Technical Bulletin

Model
911C2/C4

Subject: Seat Belt Bolt Cover, Deformed

Number
9004

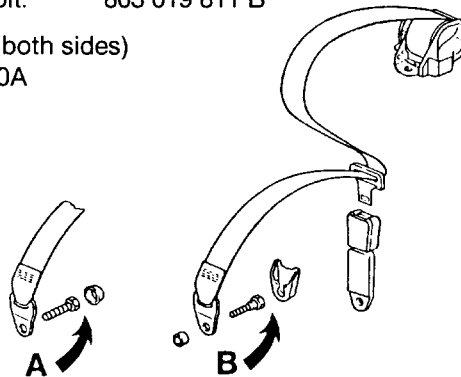
Concern: Hot air from the engine heats up the right rear seat belt anchor bolt and deforms the plastic bolt cover.

Vehicle Information: A modified anchor bolt cover is installed from production date:
August 28, 1989

Remove bolt cover and bolt (A in Figure). Install new bolt, bushing and cover (B in Figure). Torque bolt to 50 Nm (37 ft. lbs.).

Both sides, left and right should be modified.
